The applicants propose partial demolition and construction of new second story addition and deck at the subject property.

**APPLICATION FOR
HISTORIC AREA WORK PERMIT**
HISTORIC PRESERVATION COMMISSION
301.563.3400

RENOVATION OF & ADDITION TO THE
CAIRNS RESIDENCE

1
A201
PROPOSED NORTH ELEVATION
SCALE: 1/4" = 1'-0"

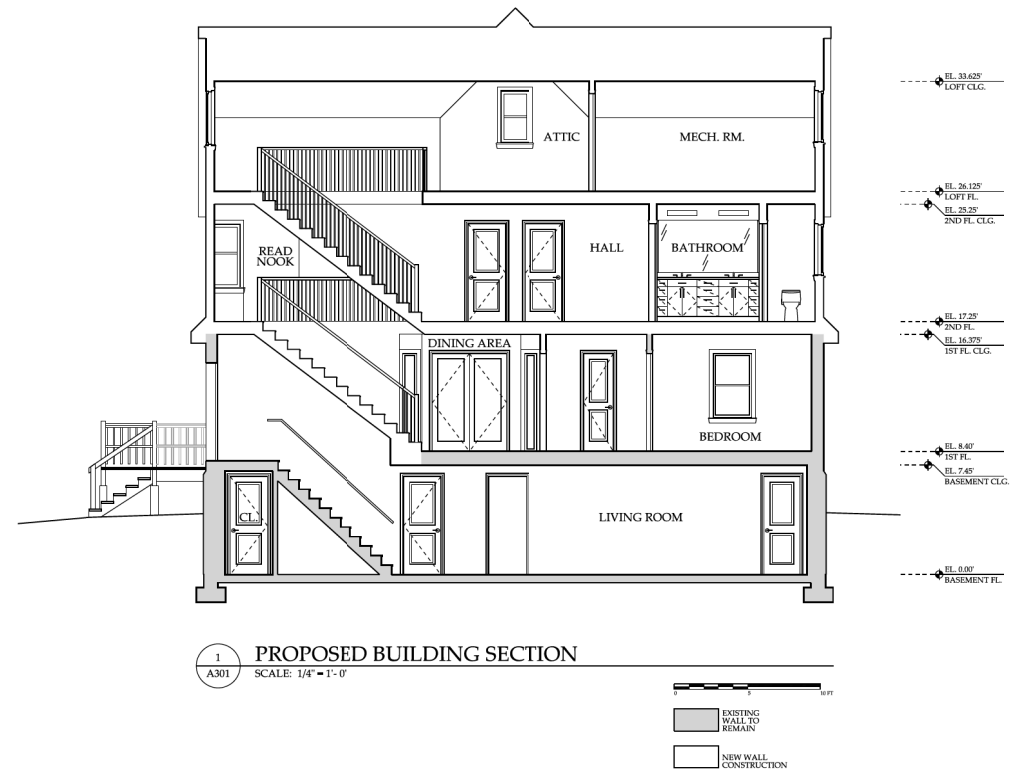
- Reducing the size of the proposed side cross gables and treating them as true dormers.
- Lowering the proposed front gable to the same height as the proposed side gables for a more consistent massing and design.

- Exploring replacement of the existing windows on the front elevation or breaking up the proposed new windows on the front elevation for consistency and to reduce the heavy appearance of the second story expansion.
- Exploring ways to reduce the “heavy” appearance of the proposed front gable on top of, and in relation to, the existing first story.

The applicants have revised their proposal and returned with a HAWP application. Specifically, the depth of the soffits and rake overhangs of the main roof have been increased by 1’, and those of the dormers have been increased by 6”. As noted in the application, the intention of this revision is to provide additional roof surface, visually separating the dormers from the exterior walls below, and ensuring that the dormers are perceived as true dormers, per the Commission’s recommendations. The revisions also include simplified trim details, visually lightening the appearance of the addition. On the east (left) elevation, a window at the top of the stairs has also been removed from the proposal, in response to privacy concerns expressed by the neighbor to the east.

In response to the Commission’s recommendations regarding the height and “heavy” appearance of the proposed front gable, the applicants have stated that, given that the footprint of the existing house is very modest, and the proposed second floor and attic are slightly smaller than the first floor, any reduction in the height or footprint of the proposed second floor addition is very challenging. The applicants explored reducing the size of the second floor to address the Commission’s comments, but they encountered challenges regarding code compliance. Specifically, the code required landings on the stairs to the second floor would have to be eliminated, and the ceiling height at the top of the attic stair would not be code compliant. The application also states that any reductions to the proposed second floor would also significantly impact the functionality of the second floor bedrooms, bathrooms, and laundry room.

Thus we had to address the HPC's comments in alternative ways. The most significant changes to this revised design are that we have increased the depth of the soffits and rake overhangs of the main north-south roof by a foot, as well as the roofs and soffits of the dormers by six inches. We believe this results in the dormers reading more like dormers by visually separating them more from the existing first floor exterior walls with greater roof surface on the sides and below the dormers, as encouraged by the HPC during their deliberations at the preliminary consultation. We also have simplified some of the horizontal trim details which we believe visually lightens the facades also in response to the HPC's comments. Lastly we have removed the window on the East elevation at the top of the new stairs to the second floor in response to the East neighbor's concerns for visual privacy.
